RE: **Lot 8 Block 13 Unit 5 SAD 227**
Volcano Cliffs
6515 Jade Rd. NW
Grading and Drainage Plan
Engineers Stamp Date 2/2/2020 (E10D097)
Pad Certification Date 5/2/2021

Based upon the information provided in your submittal received 5/7/2021, this plan is approved for Building Permit.

DRAINAGE AND TRANSPORTATION INFORMATION SHEET (REV 6/2018)

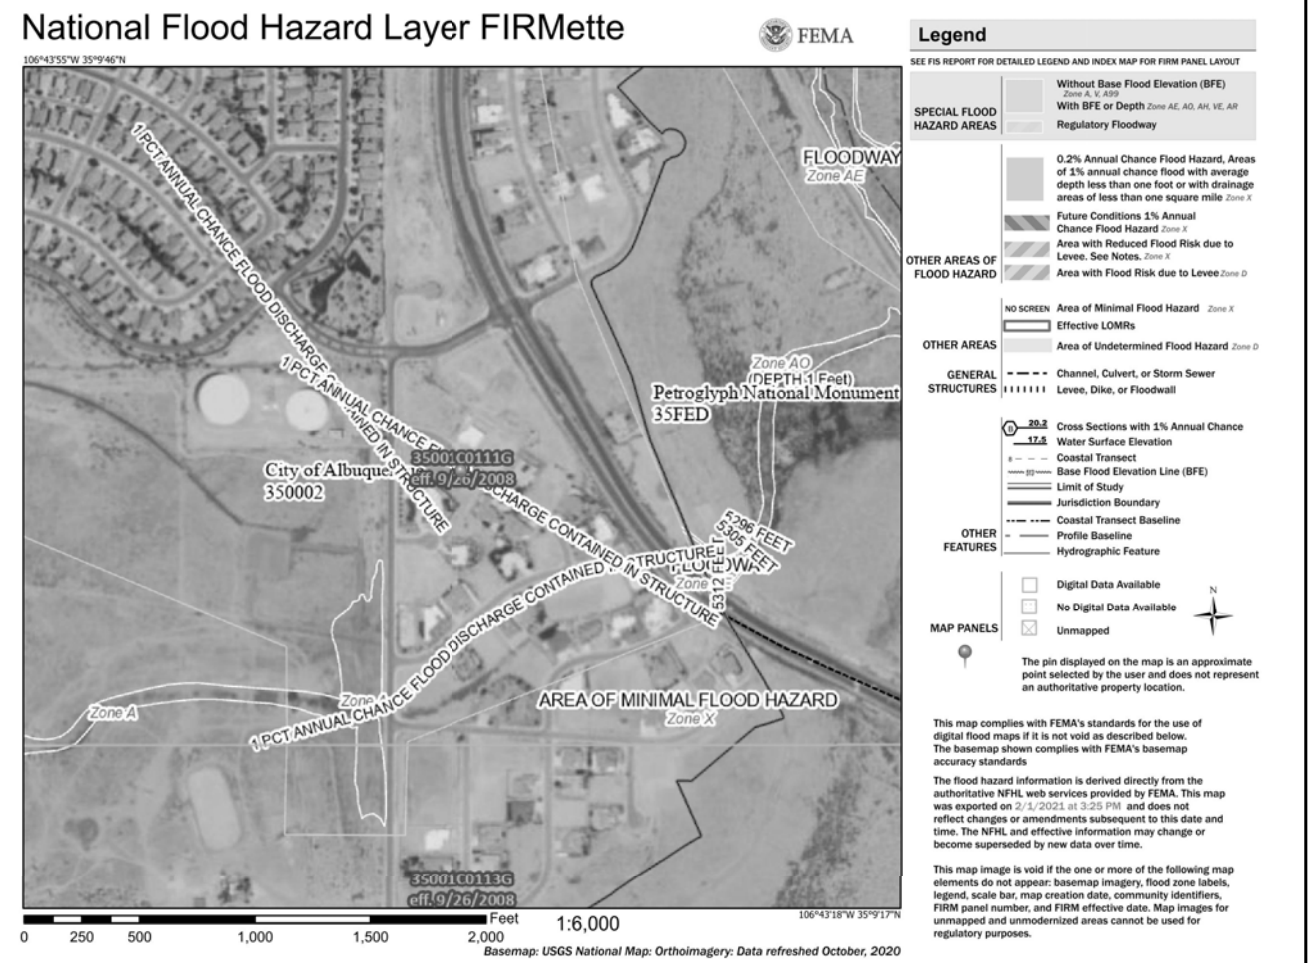
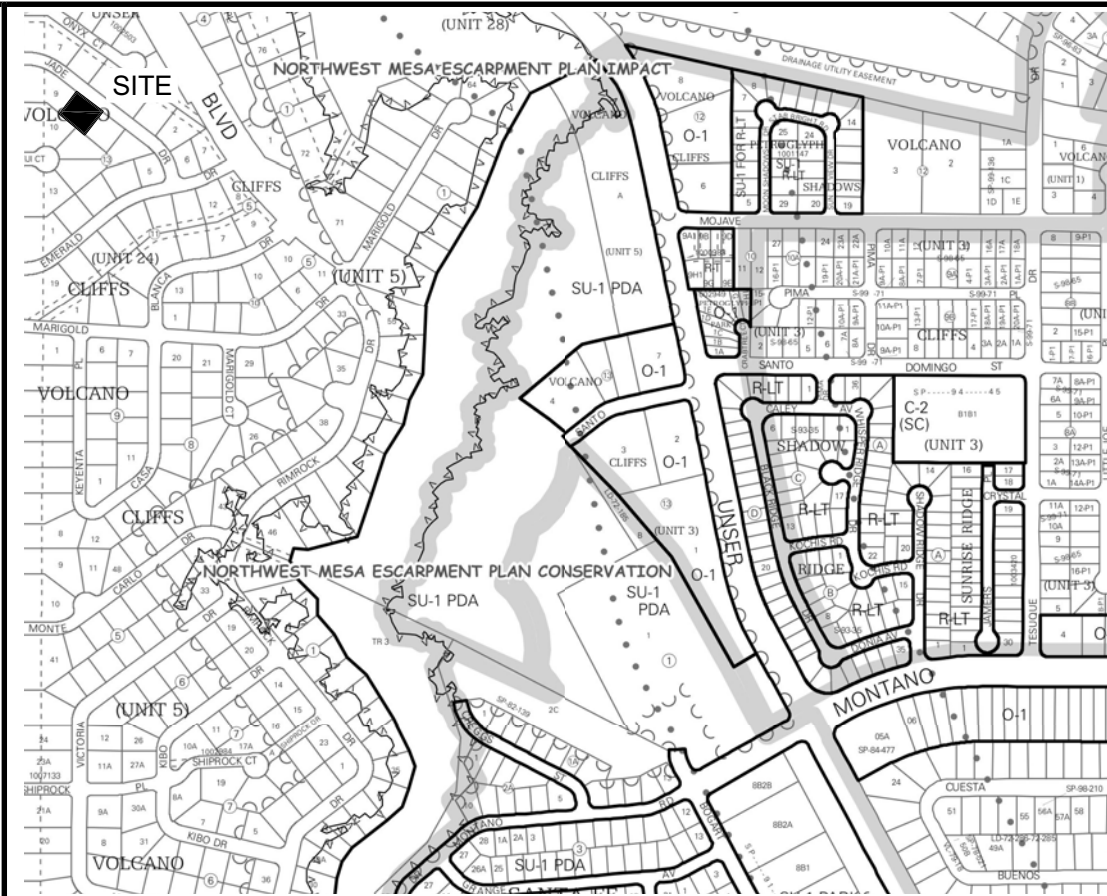
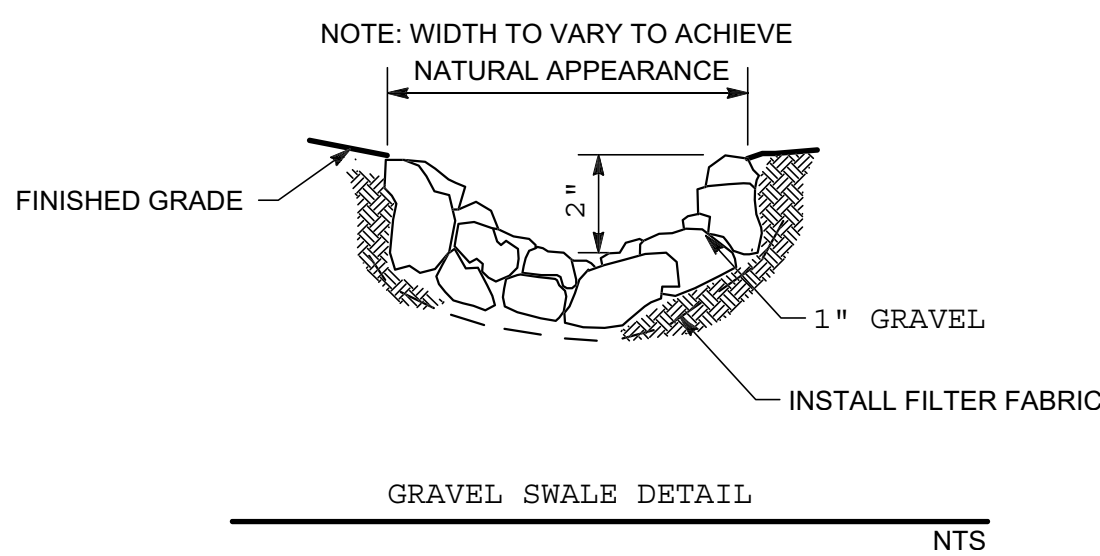
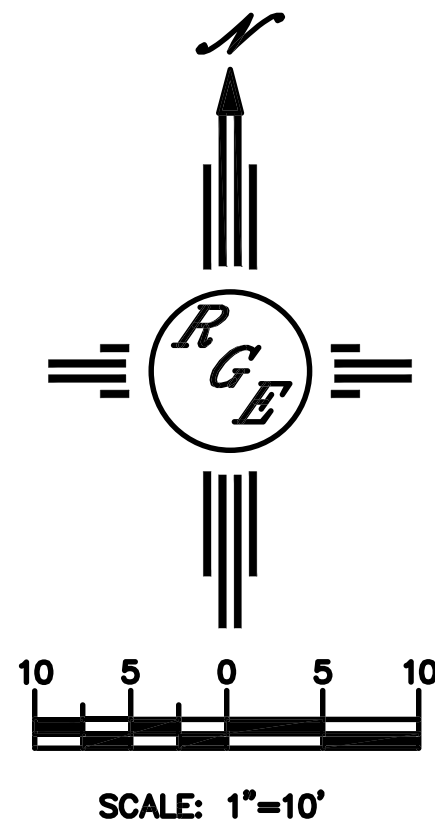
Reiterate to the Owner/Contractor that a separate permit for a garden/retaining wall must be obtained, with the approved G&D plan.

Prior to Certificate of Occupancy release, Engineer Certification per the DPM checklist of this plan will be required.
